May 1, 2026

LINCOLN PUBLIC SCHOOLS
LUX MIDDLE SCHOOL ROOF RENOVATION
LINCOLN, NEBRASKA

ADDENDUM #1

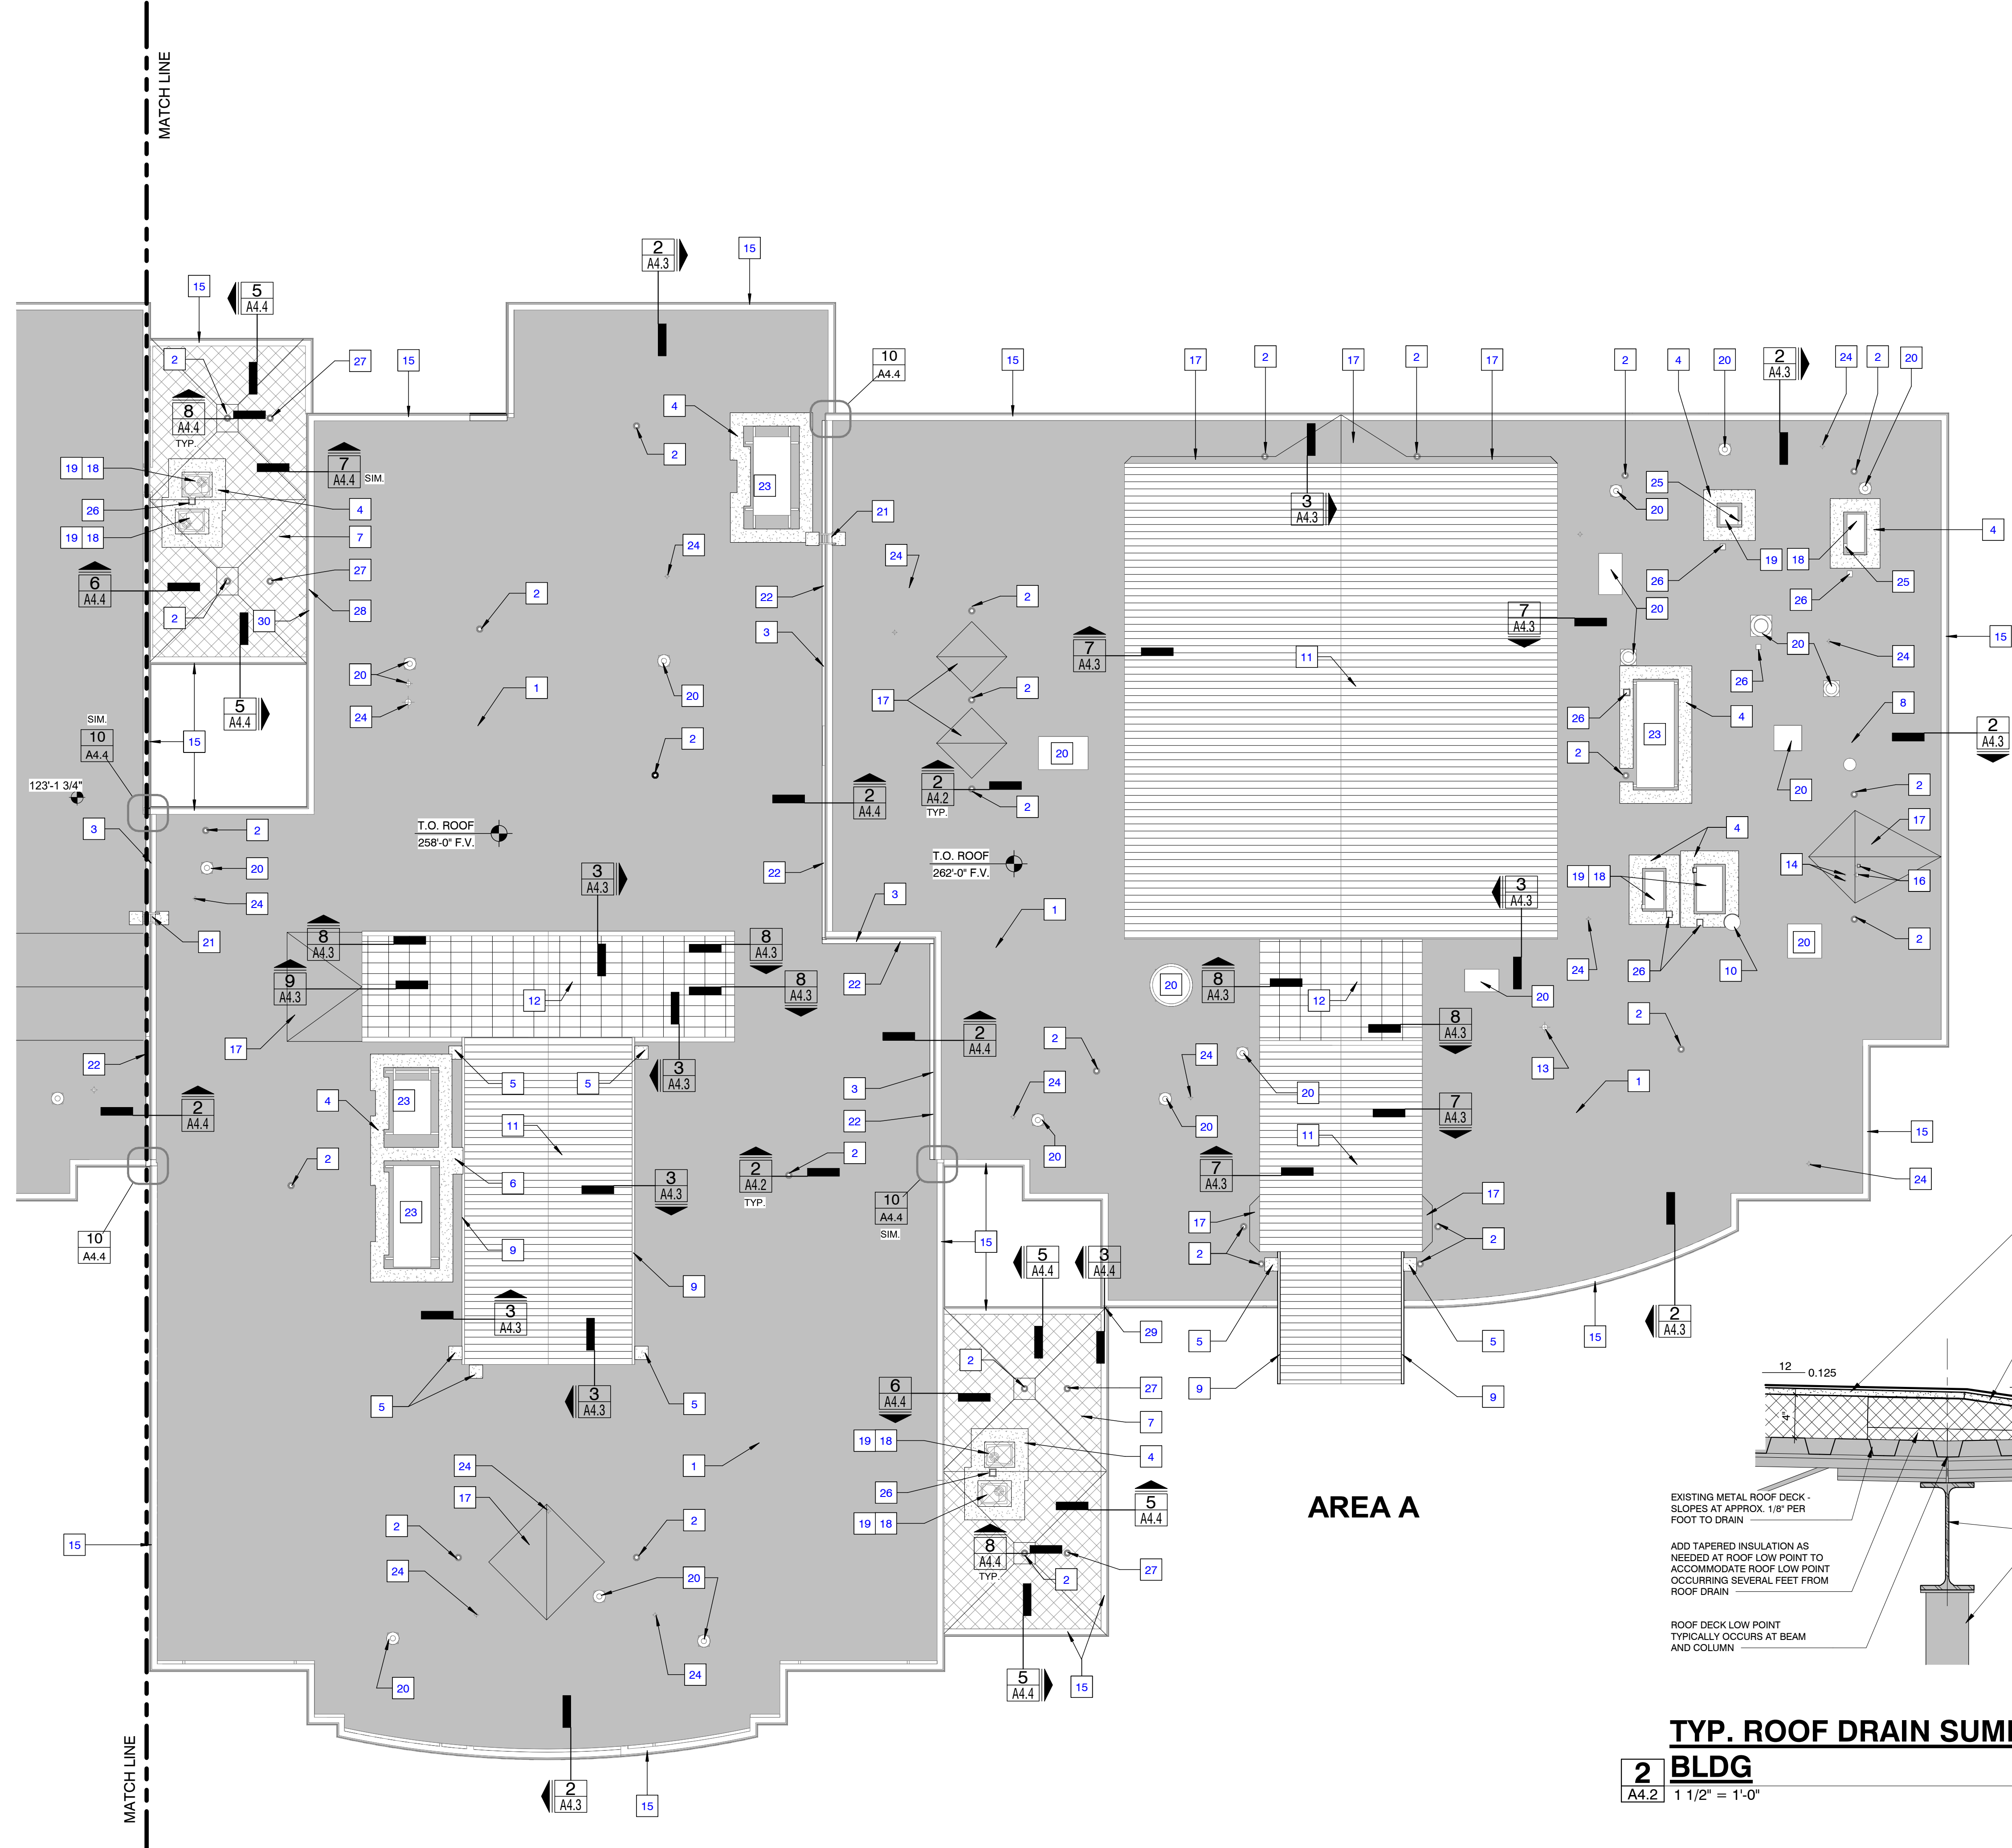
- A. Delete Sheet Keynote No. 21 and substitute the following: “21. By Deduct Alternate A-1 - Delete the work to remove and replace the backer rod and sealant at each brick expansion joint (approx. 14'-8" O.C.-F.V.), and at each cast stone control joint (approx. 7'-4" O.C.-F.V.) and at continuous horizontal joint between cast stone and brick - typ. at masonry wall areas above roof renovation areas”.

- B. At the 2021 existing modified bitumen roof edge, add detail 6, A4.3 showing the replacement of the roof edge flashing and note that this flashing work is to be deleted by Deduct Alternate A-2.

- C. Delete Sheet Keynote No. 34 and substitute the following: “34. Add 2 levels of prefinished metal roof edge fascia flashing on 2 continuous cleats at exist. modified bitumen roof system - Typ. at dashed line - total fascia flashing height 10" - Flashing to match existing height, Configuration and elevation - Wrap metal up and over top of wood blocking - Flash metal into existing modified bitumen roof membrane for weather-tight condition - Delete this work by Alternate A-2”.

1 ROOF RENOVATION PLAN - EAST
 1/16" = 1'-0"

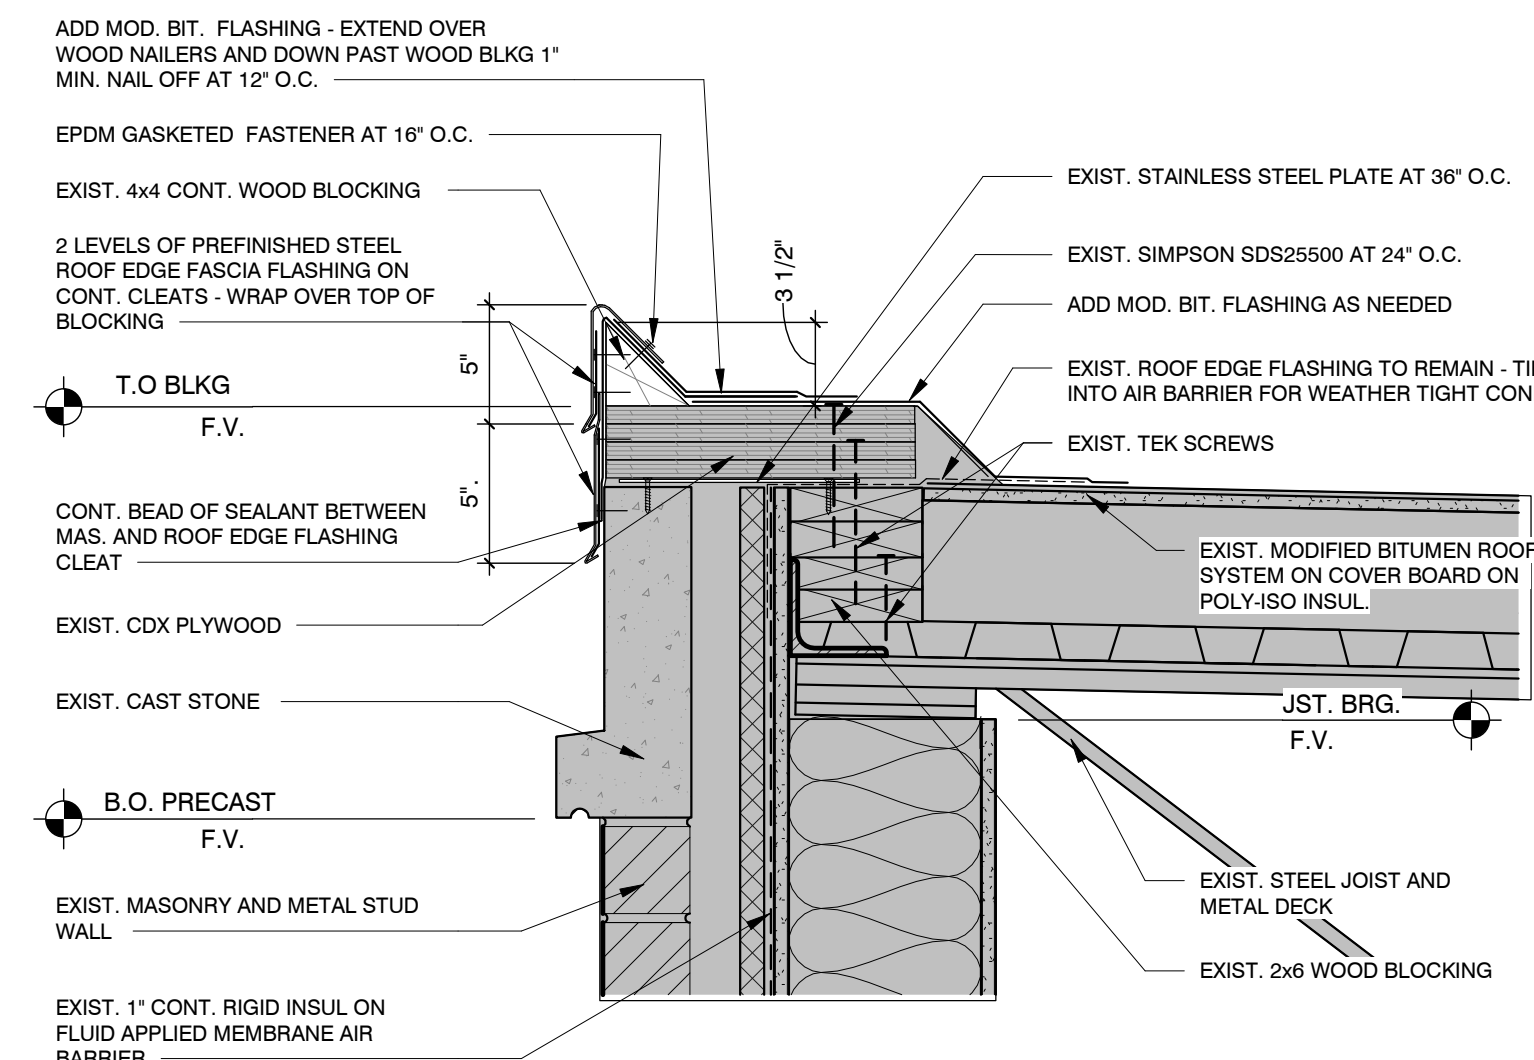
- A. Delete Sheet Keynote No. 22 and substitute the following: “22. By Deduct Alternate A-1 - Delete the work to remove and replace the backer rod and sealant at each brick expansion joint (approx. 14'-8" O.C.-F.V.), and at each cast stone control joint (approx. 7'-4" O.C.-F.V.) and at continuous horizontal joint between cast stone and brick - typ. at masonry wall areas above roof renovation areas”.

6 ROOF
A4.3 1 1/2" = 1'-0"

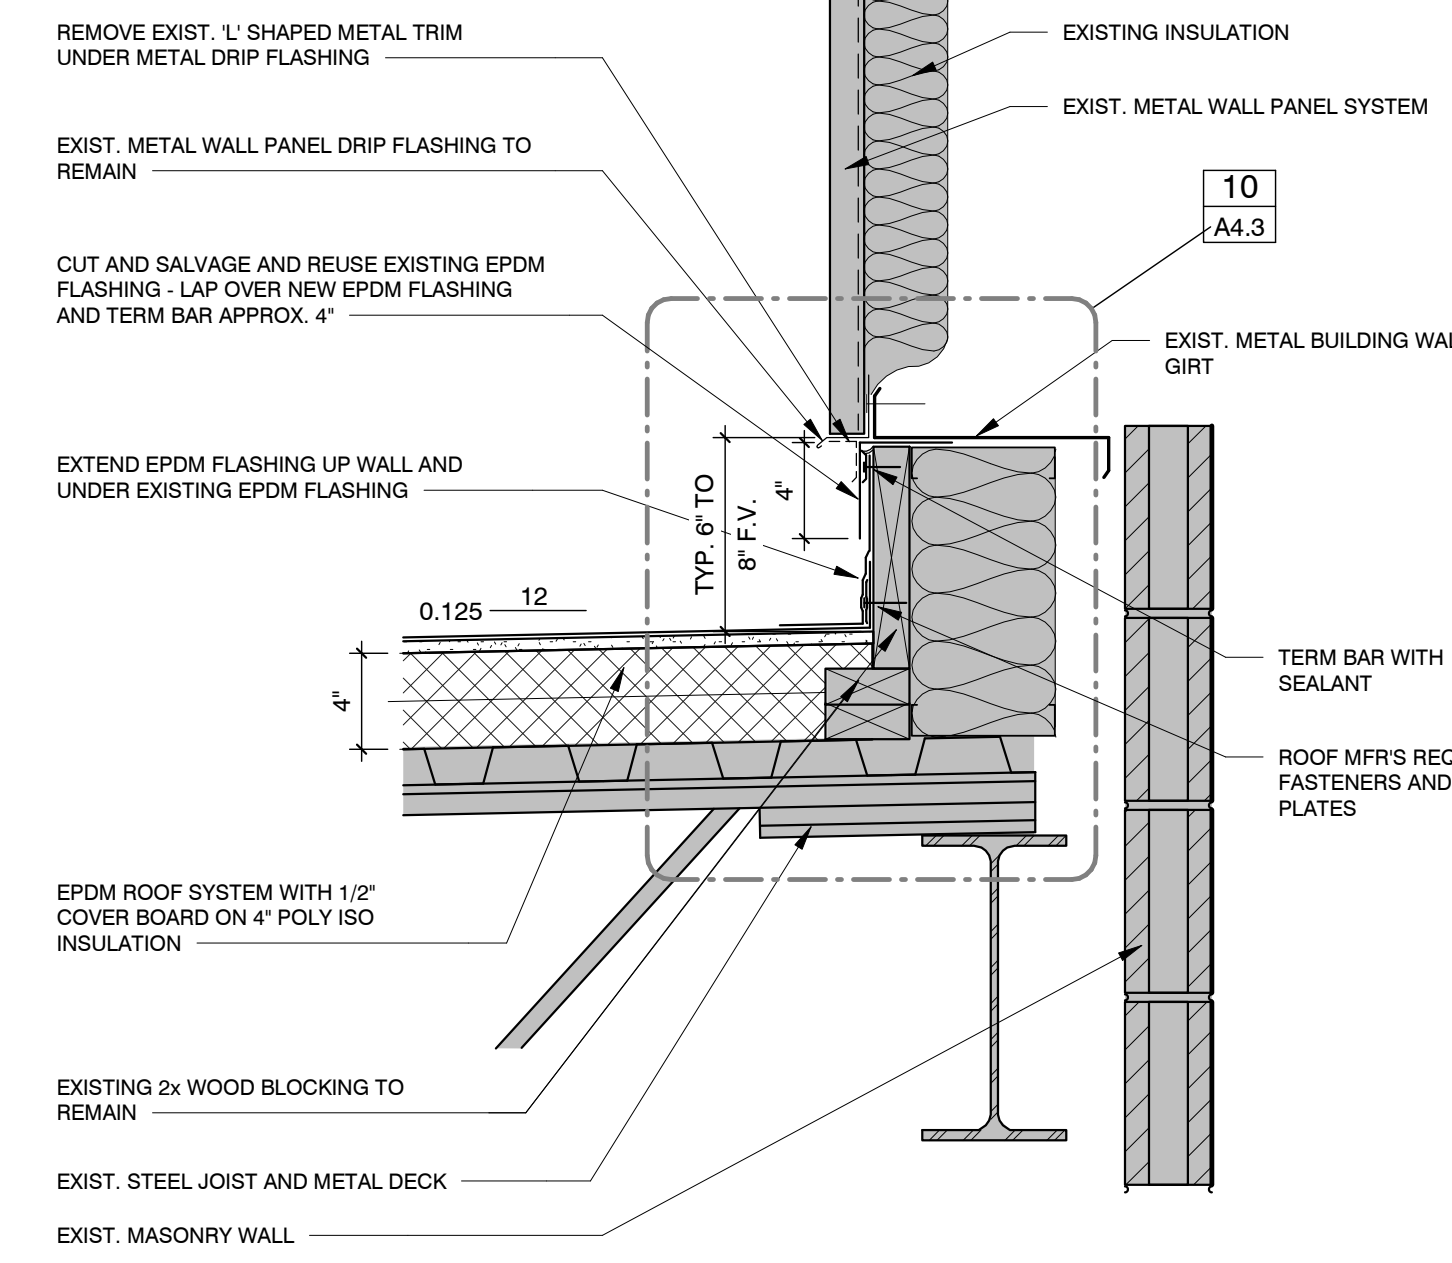
- A. Add Detail No. 6 – Replace Flashing at Exist. Mod. Bit. Roof – Showing roof edge flashing replacement at the existing 2021 modified bitumen roof edge, and a note to delete this work by Deduct Alternate A-2.

1 TYP. ROOF STEP DEMO. DETAIL

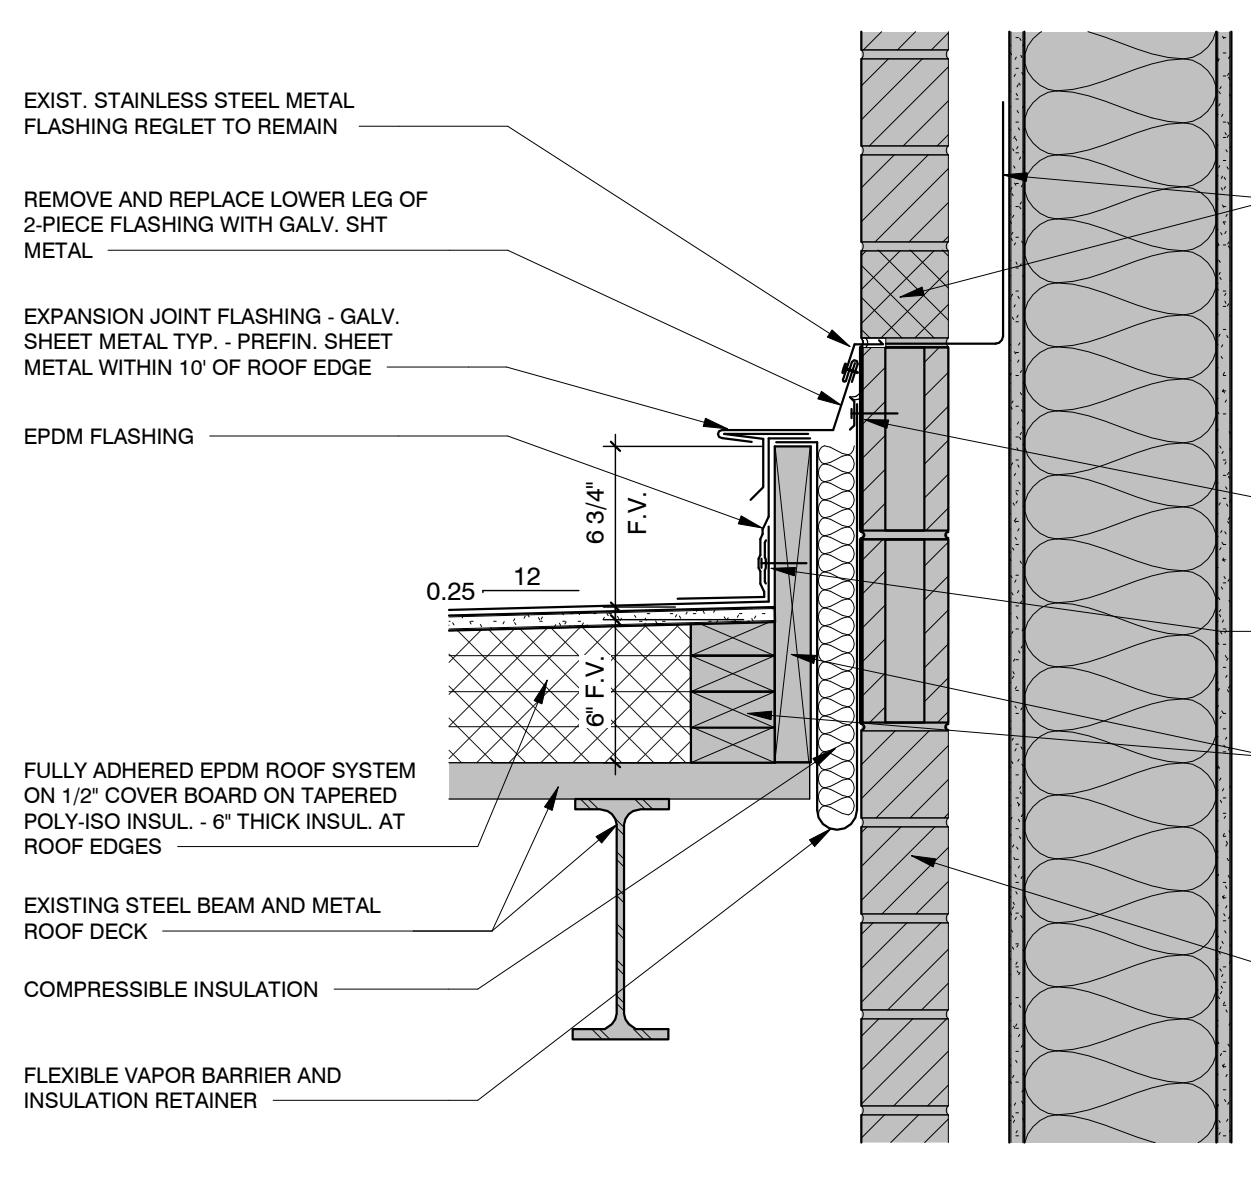
- A. At Detail No. 1 – Add the following note: “Remove backer rod and sealant - Delete this work by ALT. A-1”.
- B. At Detail No. 1 – Add the following note: “Remove backer rod and sealant at cast stone control joints and at brick expansion joints above roof renovation areas - Delete this work by ALT. A-1”.
- C. At Details No. 2 and 3 – Add the following note: “Add backer rod and sealant - Delete this work by ALT. A-1”.
- D. At Details No. 2 and 3 – Add the following note: “Add backer rod and sealant at cast stone control joints and at brick expansion joints above roof renovation areas - Delete this work by ALT. A-1”.
